# NORTHEAST UTILITIES

Docket No. 50-423

Millstone Nuclear Power Station, Unit No. 3  
Seismic Qualification Review Team (SQRT) and Pump and Valve  
Operability Review Team (PVORT) Audits

Responses to SQRT Audit Questions

FIGURE 1

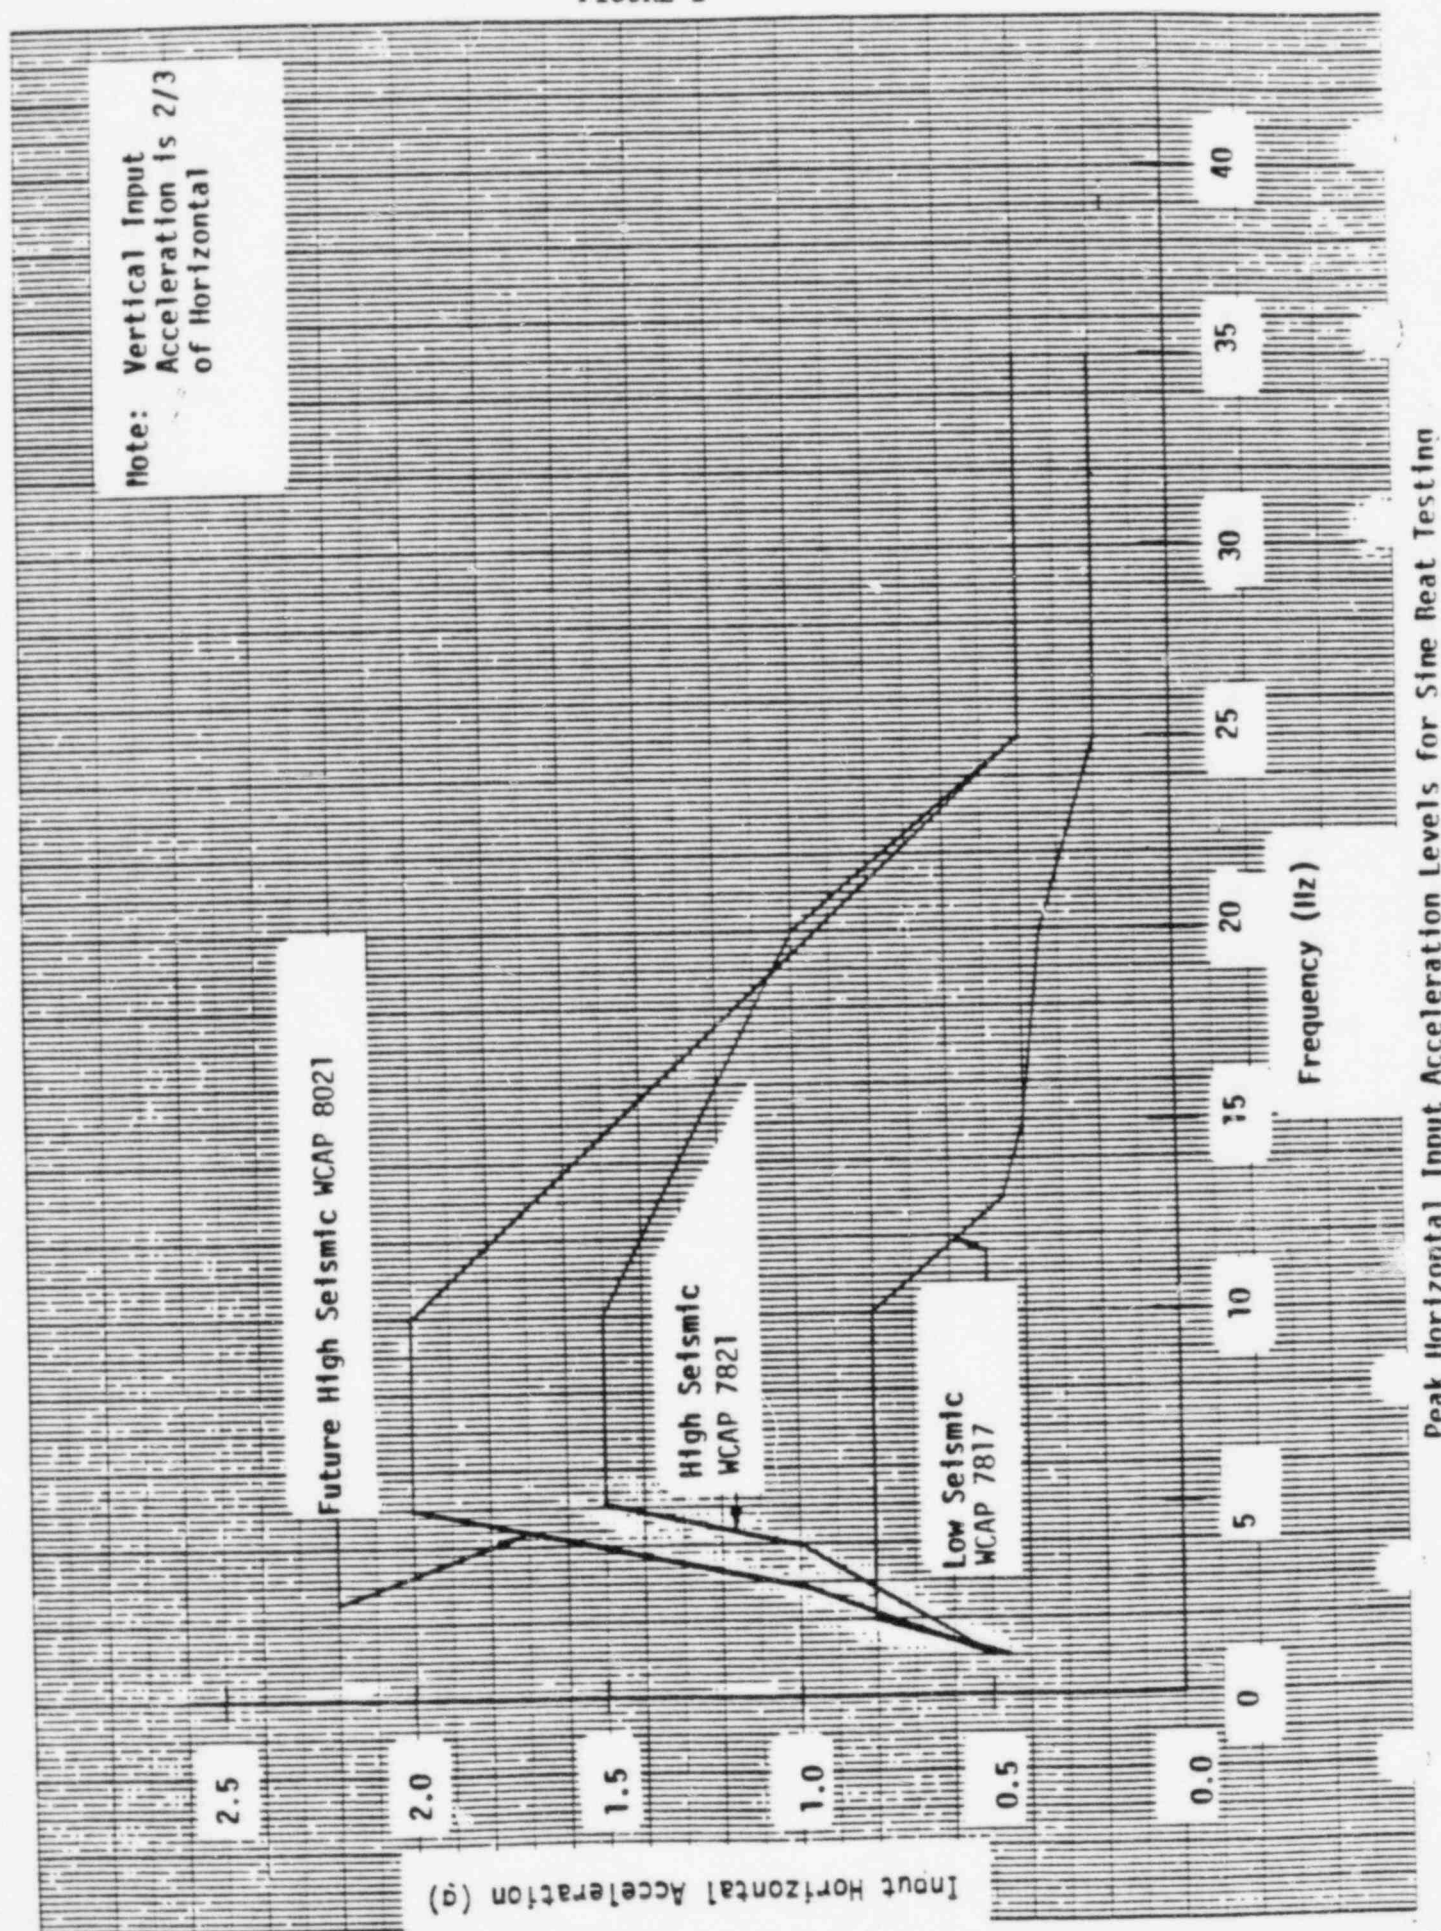
Westinghouse will provide a Millstone 3 specific demonstration that the tests performed for the NIS console provided the equivalent of 5 OBEs and 1 SSE.

The NIS console was qualified for Millstone 3 application to the high seismic level as shown in Figure 1. The predominant natural frequencies of the NIS console were found at 5.0 to 7.7 Hz in the horizontal directions, while the NIS console was found to be rigid (resonances above 33 Hz) in the vertical direction. The NIS console is mounted in the Millstone 3 control building at elevation 47 ft. The Millstone 3 response spectra associated with this mounting location are provided in Figures 2 through 7.

The required seismic fatigue stress cycles shall be computed at the lowest natural frequency in each principal axis of the equipment less than or equal to 33 Hz. For the NIS console the computation shall be based on a natural frequency of 5 Hz. The maximum Millstone 3 spectral accelerations associated with this frequency are 0.55g at 4% damping for an OBE event and 1.05g at 4% damping for an SSE event.

The above comparisons demonstrate the test fatigue stress cycles exceed the required fatigue stress cycles by a considerable amount. Therefore, based on the fatigue evaluation performed and documented herein, it is concluded that the Millstone Unit 3 fatigue requirements have been met by the single frequency seismic testing performed by Westinghouse on the NIS console.
